Melrose Heights / Oak Lawn Architectural Conservation District

DESIGN/DEVELOPMENT REVIEW COMMISSION
DESIGN REVIEW DISTRICT
HISTORIC AGENDA
EVALUATION SHEET
Case # 2

ADDRESS: 1420 Hagood Avenue

NATURE OF REQUEST: Request Certificate of Design Approval for new construction

Current window proposed by applicant

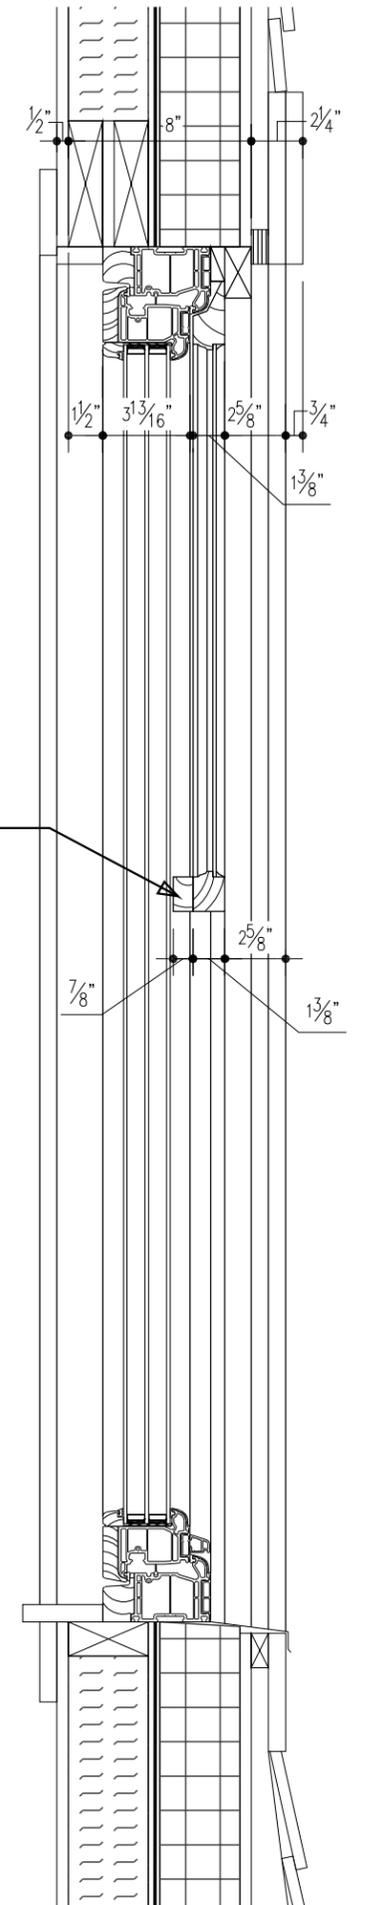
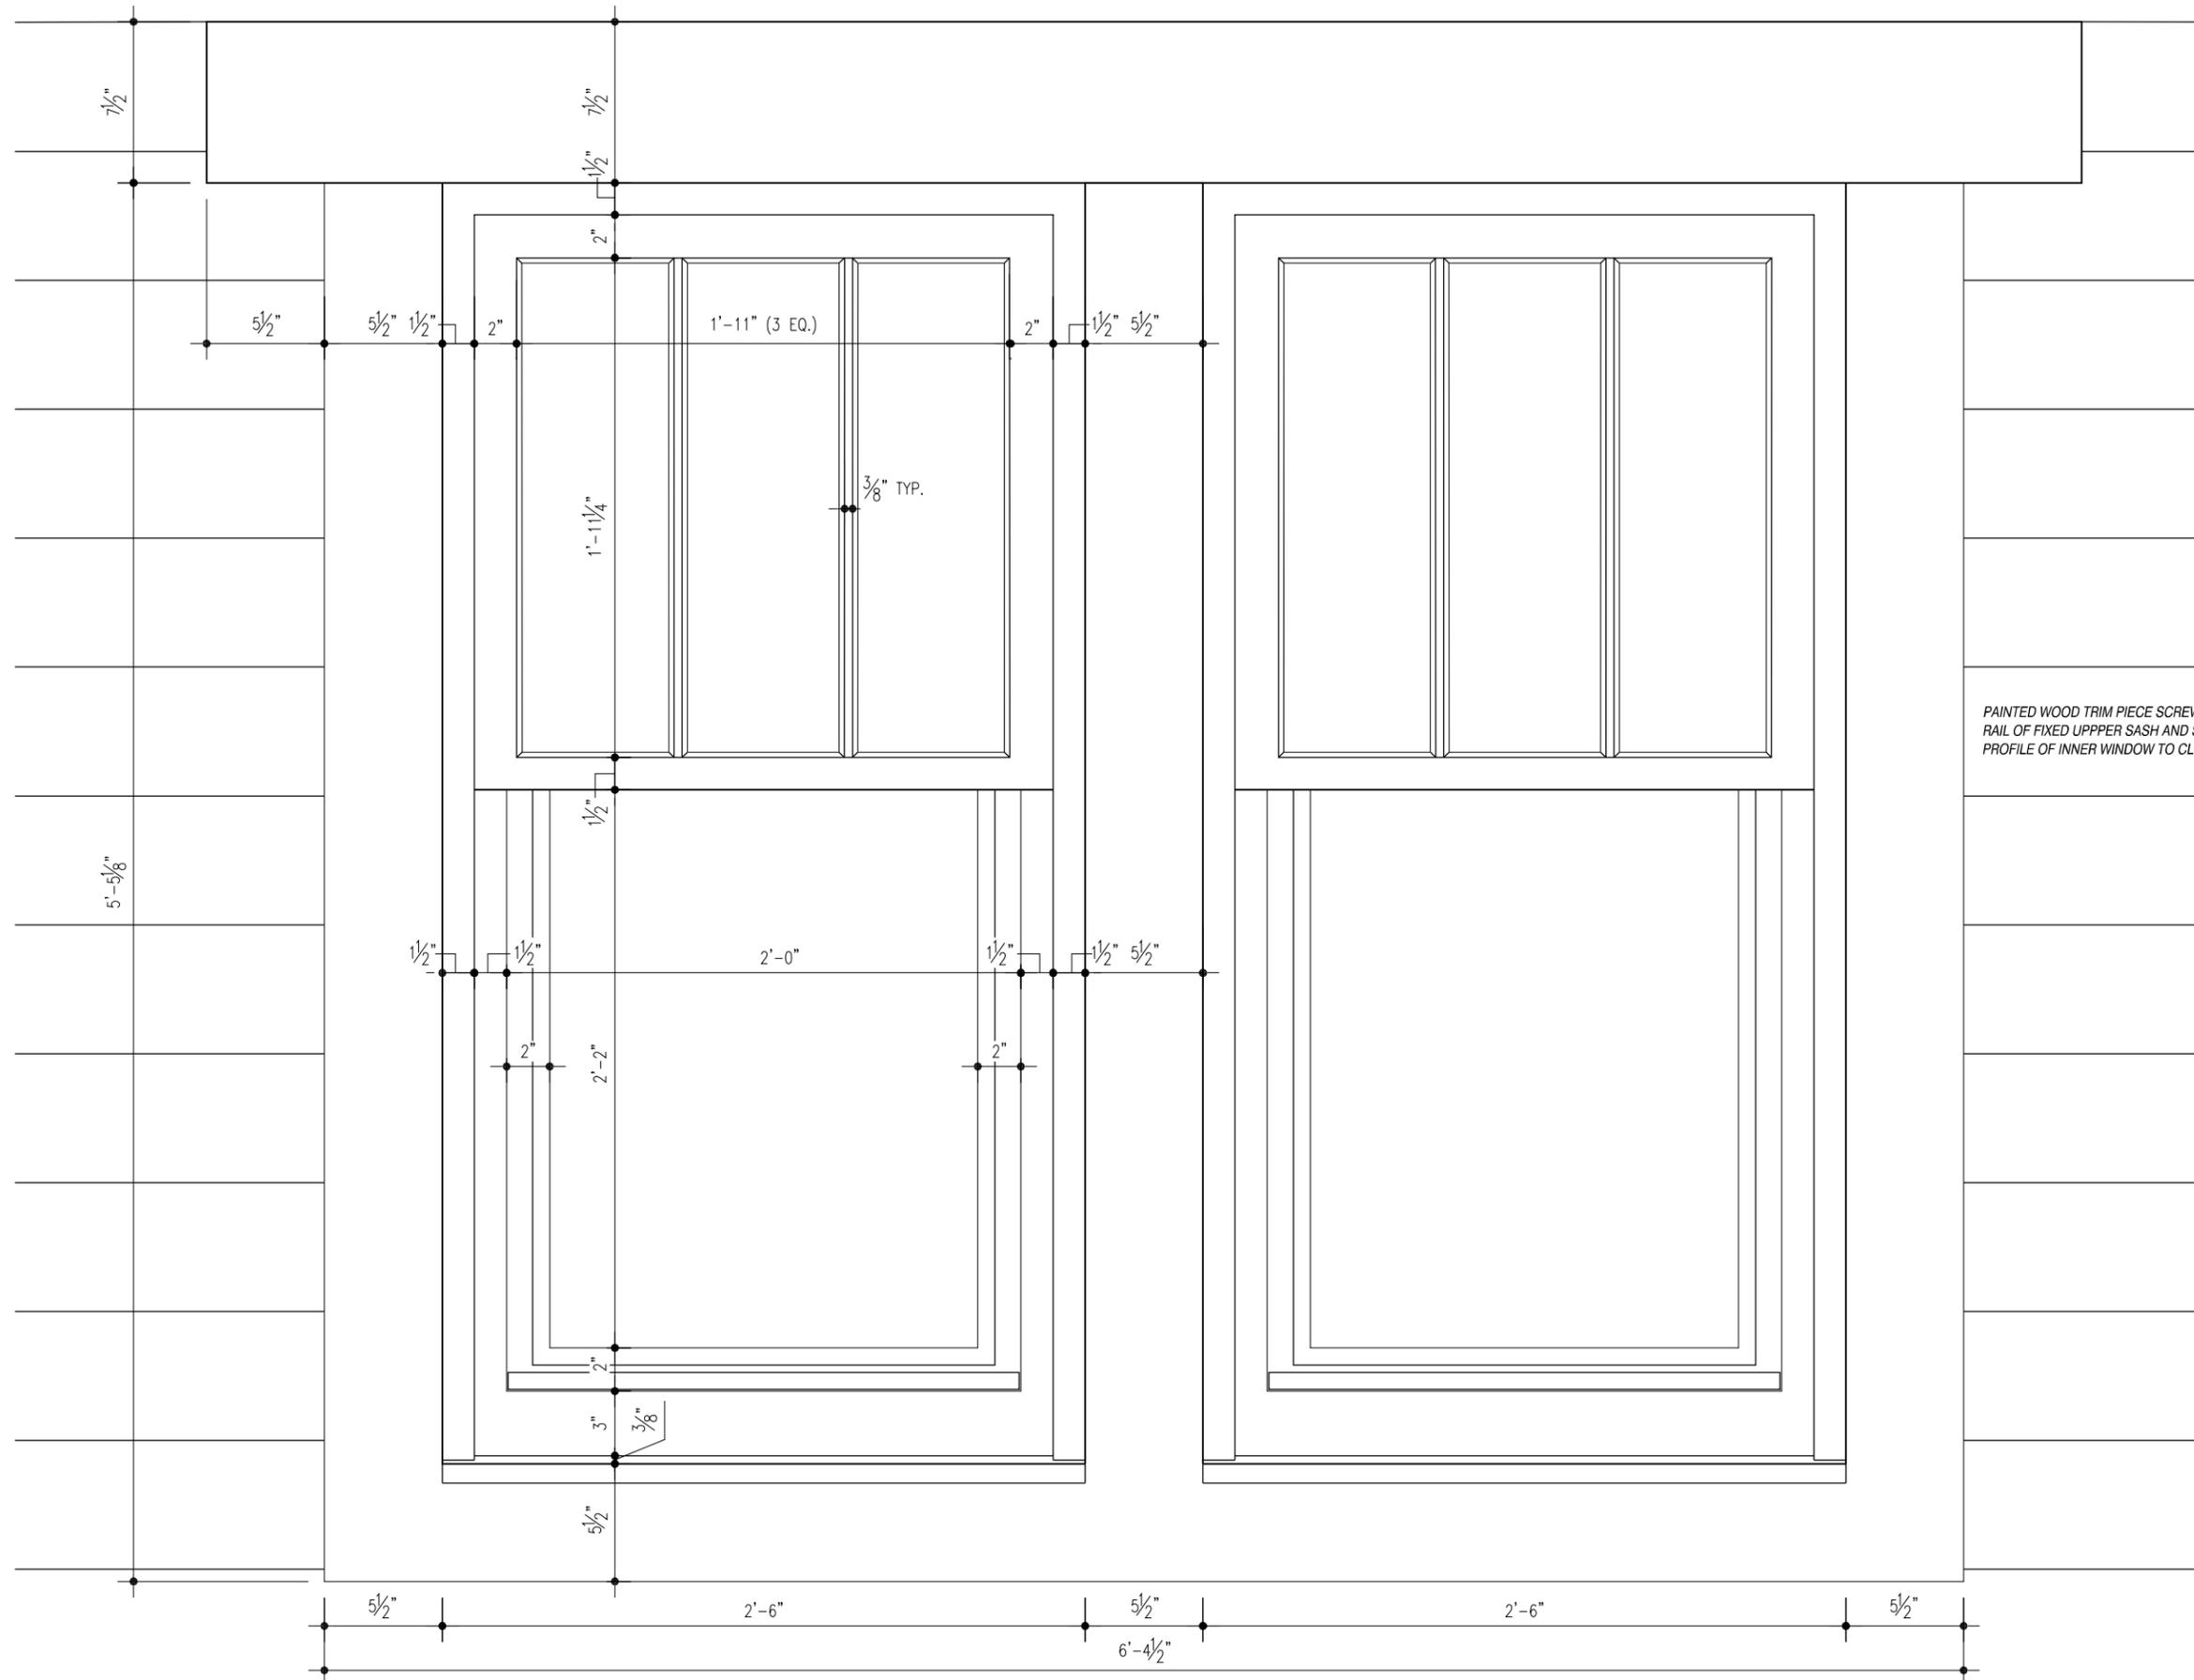
Windows: The proposed window configuration features a triple-pane, aluminum-clad casement window with a single-pane, puttied, wood top sash only placed in front of the top half of the casement.

This upper wood sash will have exterior muntins and will be in front of the casement because the applicant is suggesting this arrangement will mimic the look of a double-hung window. Historic wood windows are composed of top and bottom sash which meet in the middle side-by-side to provide a seal, and the top sash is the outermost sash.

The applicant has provided drawings of this arrangement as well as photographs of the proposed window. The side view drawing shows that the gap between the proposed wood sash and the aluminum-clad casement window has been reduced to 7/8" -or a difference of a half inch- from the previous proposal. This makes the bottom rail of the top sash appear to 2 1/4" deep, still thicker than the average historic window thickness of 1 and 3/8 inches, but not double the thickness as was previously proposed. This could be further reduced with a wood sash only 1 and 1/8 inch thick.

The bottom half of the aluminum-clad window, acting as a "bottom sash," will be visible and it has an appearance that is inconsistent with historic windows both in the district and with the new wood top sash that will be directly adjacent. This is very evident in the width of the stiles (vertical sides) of the top sash, which is 2 inches, and the "bottom" sash, or casement window, which is 3.5 inches in width. Top and bottom sashes in historic buildings do not differ in width in their stiles.

Another difference is the proportion of the top and bottom sashes at their horizontal rails. Bottom rails are often only a half inch or inch taller than the stiles are wide. In the proposal, the total height of the bottom "rail" of the casement is at least 5 inches, or more than double the 2-inch stiles of the wood top sash. It features a gasket and extra frame around the sash and is therefore bulky,

especially at the base, making it much taller and more complex in appearance than a historic wood window's bottom rail. This is better shown in photos at the end of the evaluation. Historic wood rails at the bottoms of windows are smooth wood; aluminum-clad options approved recently for new construction in the district are also smooth, with no extra gaskets or differences in stile widths between top and bottom sashes.

The combined inconsistent widths, details and proportions make the proposed windows out of keeping with the guidelines, and they will be substantial enough to be visible from the public right of way. The guidelines state to use "*architectural features that are visually compatible with those of historic buildings,*" and "*When selecting architectural details, consider the scale, placement, profile, and relief of details on surrounding structures for the basis of design decisions.*" It appears that the detailing from surrounding historic buildings was not used as a basis for design decisions for the proposed window.

The previous motion for this project allowed for a replacement window consistent with the guidelines, or the concealment of the proposed windows by an exterior window that meets the guidelines. To be consistent with the guidelines and the previous motion, the details addressed here need to be corrected: proportions of the window components should be consistent with each other and with historic windows, and there should be no visible gaskets and extra framing as they are not found on historic wood windows.

Staff finds that the proposal does not meet Section 5 of the guidelines and recommends **denial**.
